AGENDA ITEM #2

**TO:** Design Review Commission

**SUBJECT:** 14-SC-22, 910 Oxford Drive

2. **14-SC-22 – Studio 3 Design – 910 Oxford Drive**  
Design review for a second story addition to an existing one-story house. The project includes a remodel of the first story and the addition of 761 square feet on the second story. *Project Planner: Lim*

## 2<sup>nd</sup> Story house at 990 Oxford

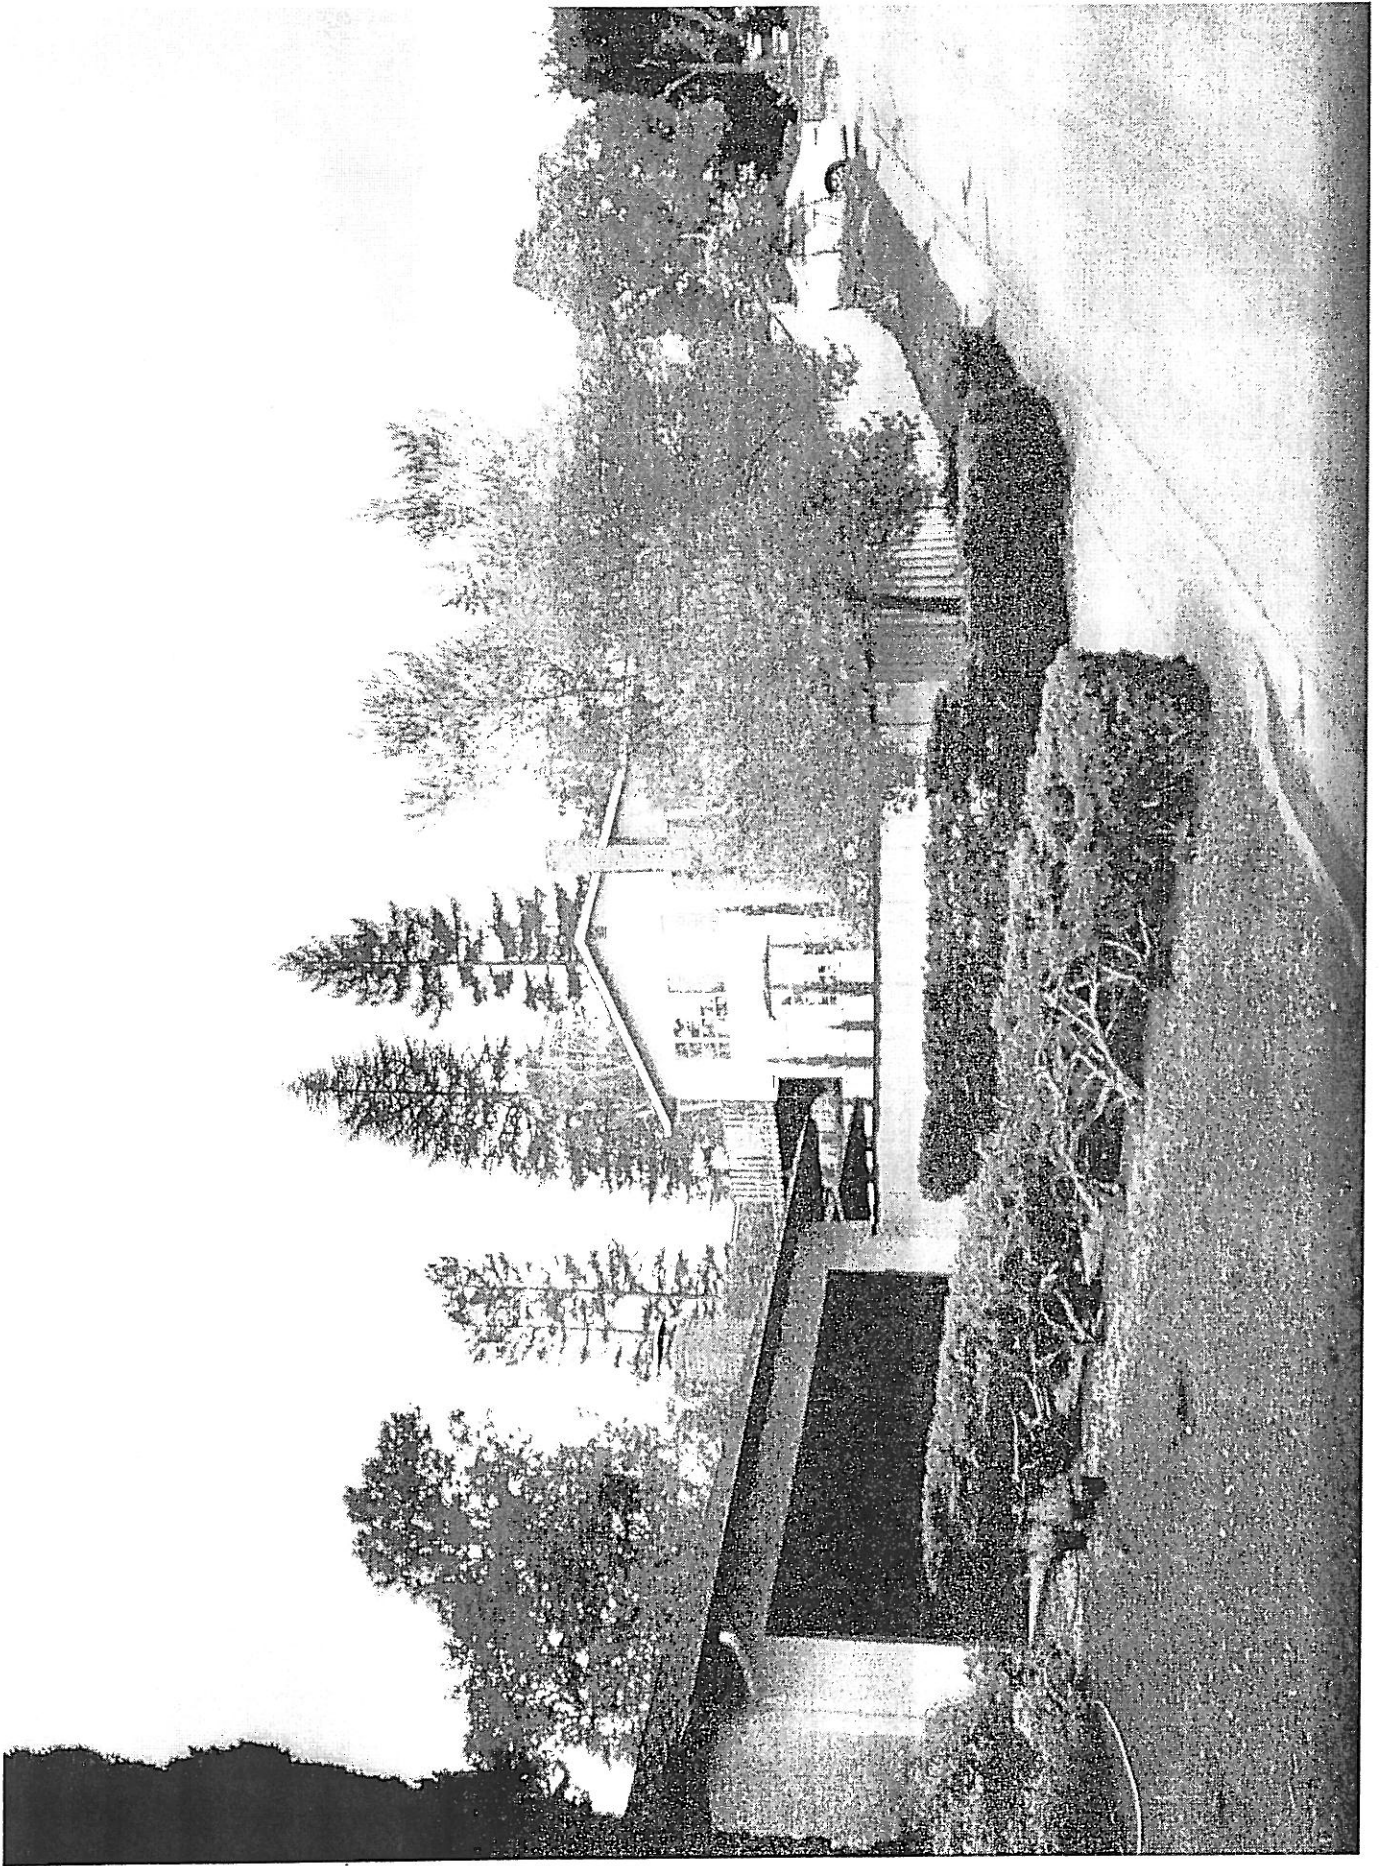
- At the other end of Oxford, overlooking a house on Kent, similar relative height situation as 910 Oxford and 2068 Kent.

# View from Kent Drive patio

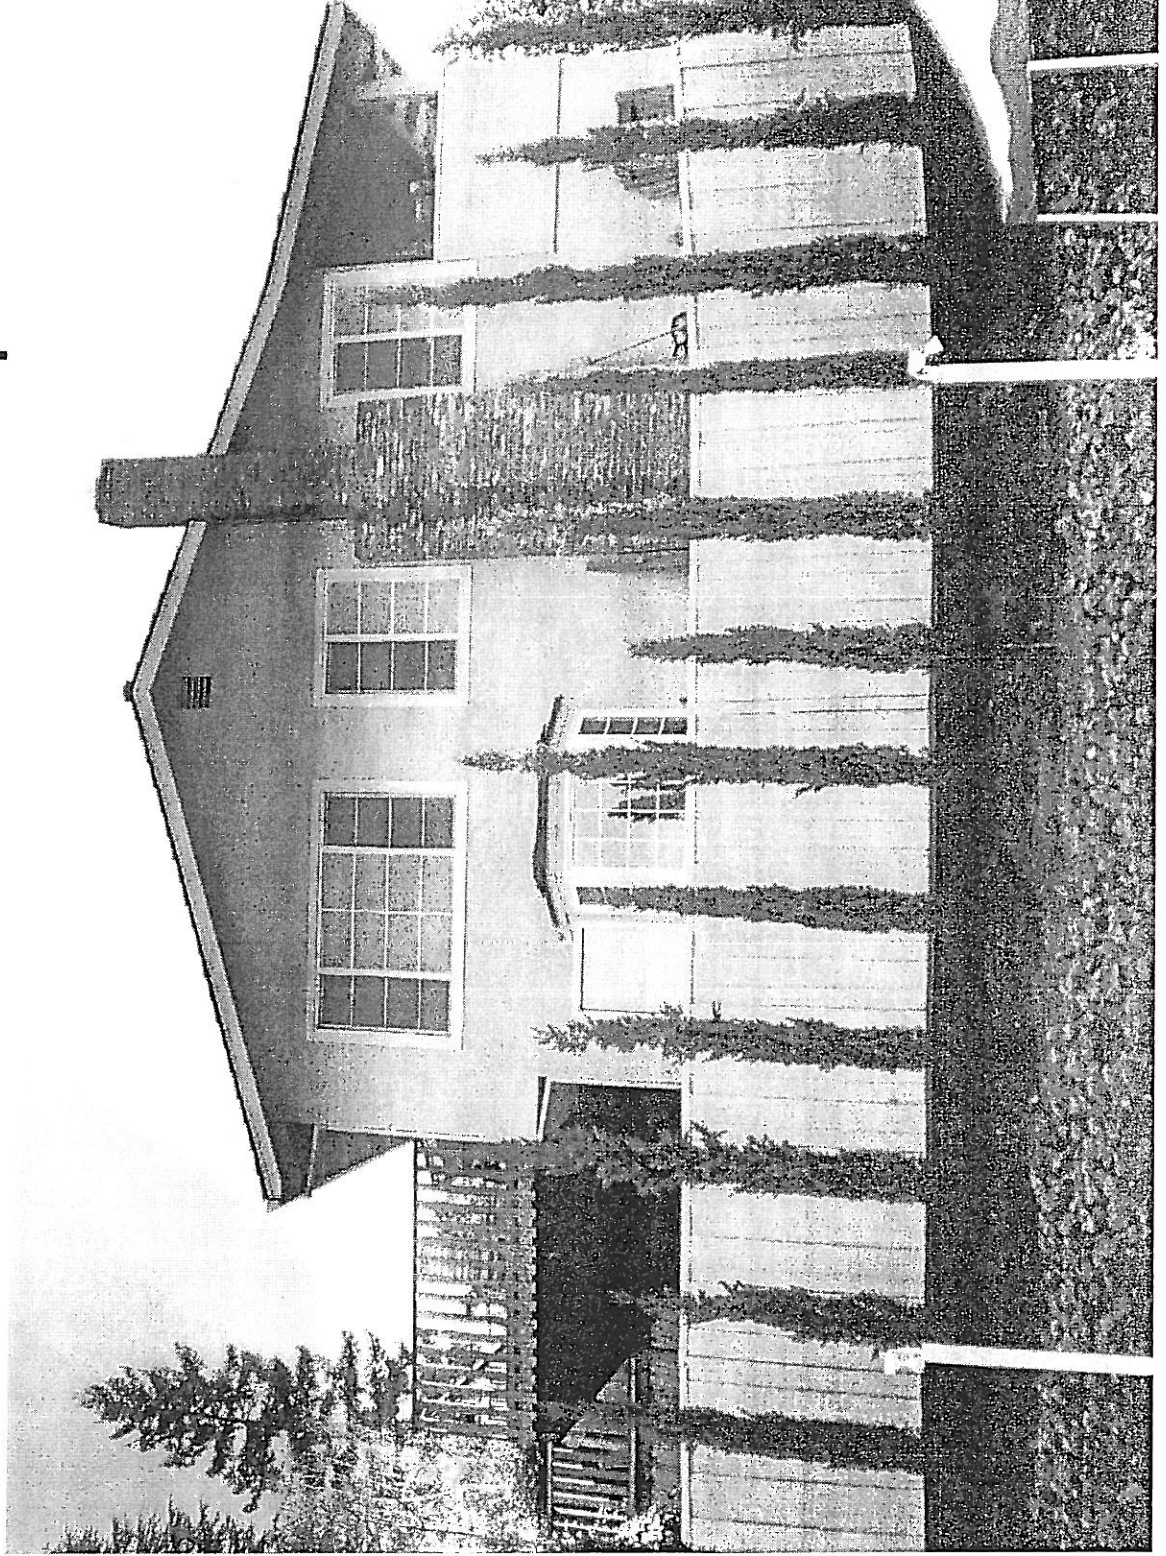
- The view will be from a proposed second story addition to a property that is already 30 feet above our house on a very steep hill. A second story adds another 10 feet.
- There are numerous call-outs in the Design Review assessment document echoing our concerns.
- We have concerns about long-term enforcement of requirements for trees and other vegetation remaining intact. Fines? After the fact recourse?

# View from Kent Drive patio/pool

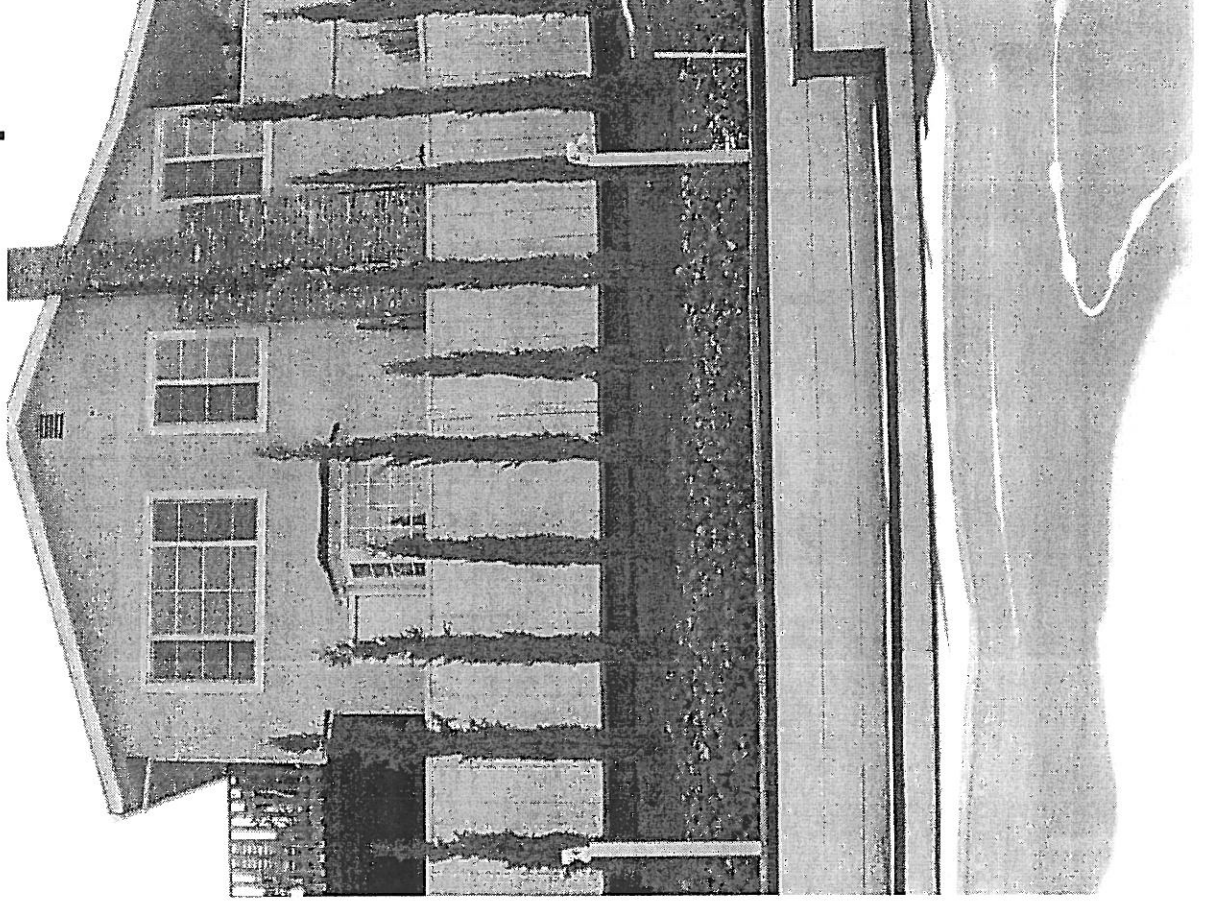
- There is a utility easement between the properties (PG&E power lines, etc.) This places an operational limit on the height of some vegetation, as PG&E periodically monitors interference with their lines.
- Vegetation has grown over 21 years to provide the current level of privacy mitigation for a one-story house and likely will not for a two-story house.
